Revision 2 June 2019

Dealer Service Instructions for:

Customer Satisfaction Notification V41 Steering Damper

2018 - 2019 (JL) Jeep® Wrangler vehicles

Figure 2 – Intake Bulge Location

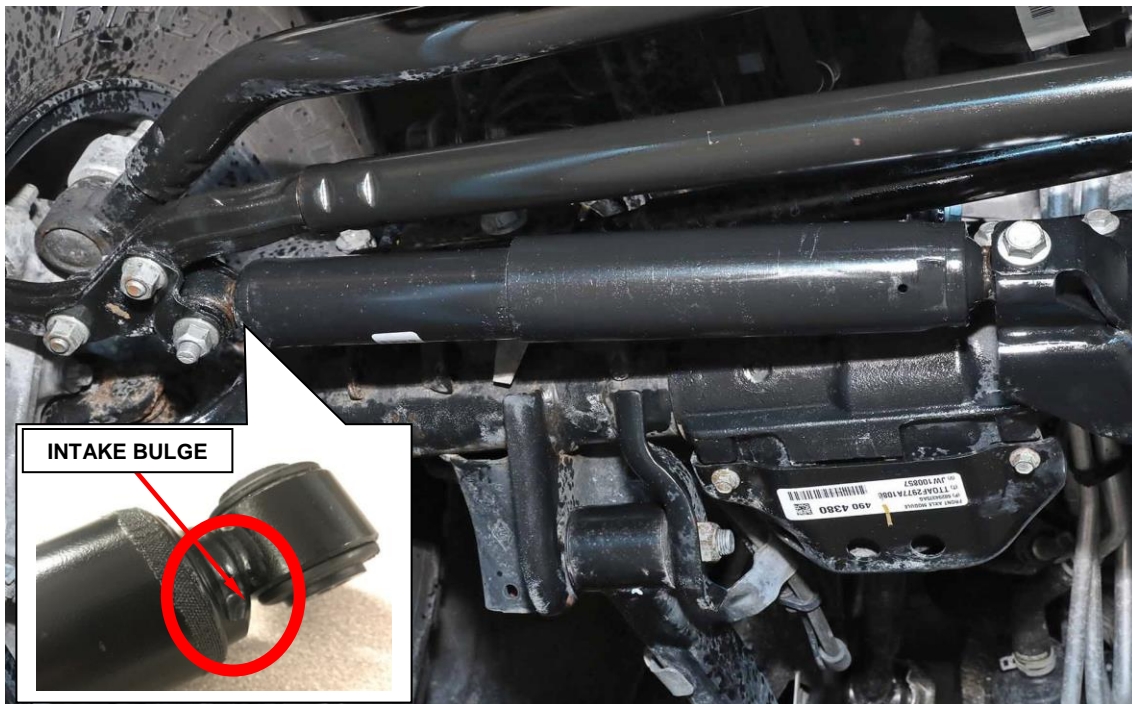
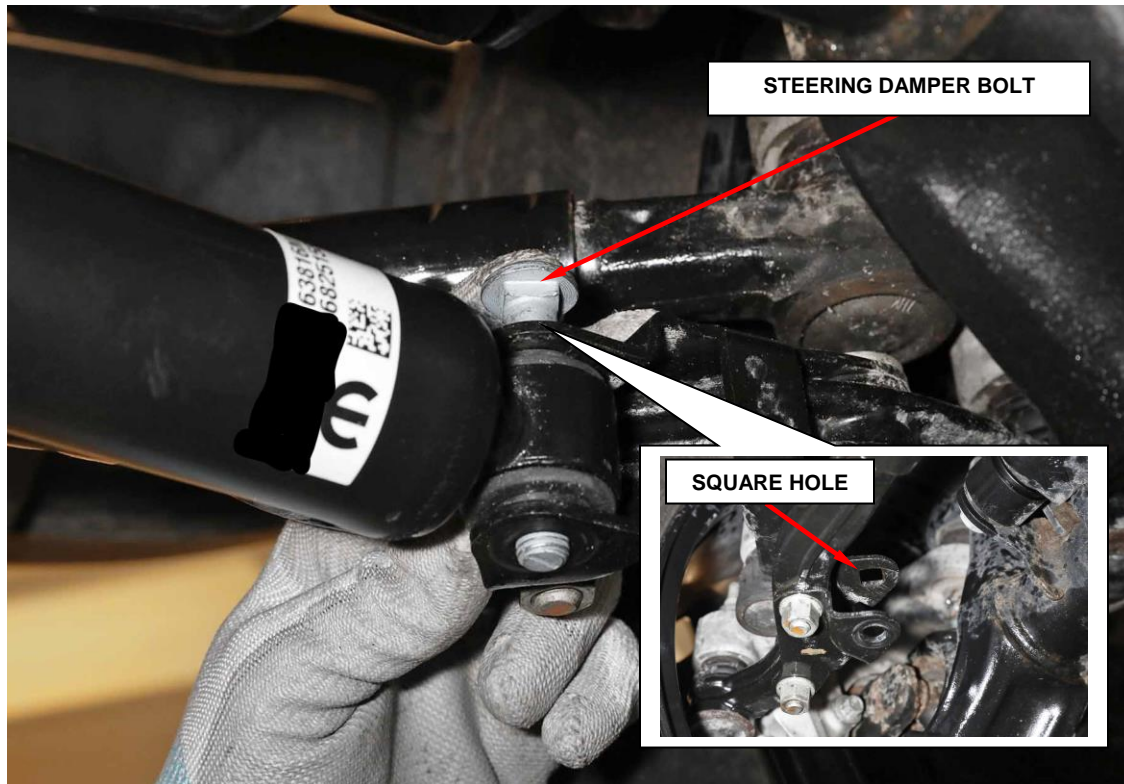
NOTE: Figure 2 position of Steering Damper Intake Bulge location updated.

NOTE: Location of side Intake Bulge on the base cup must be positioned in the **downward** position (Figure 2).
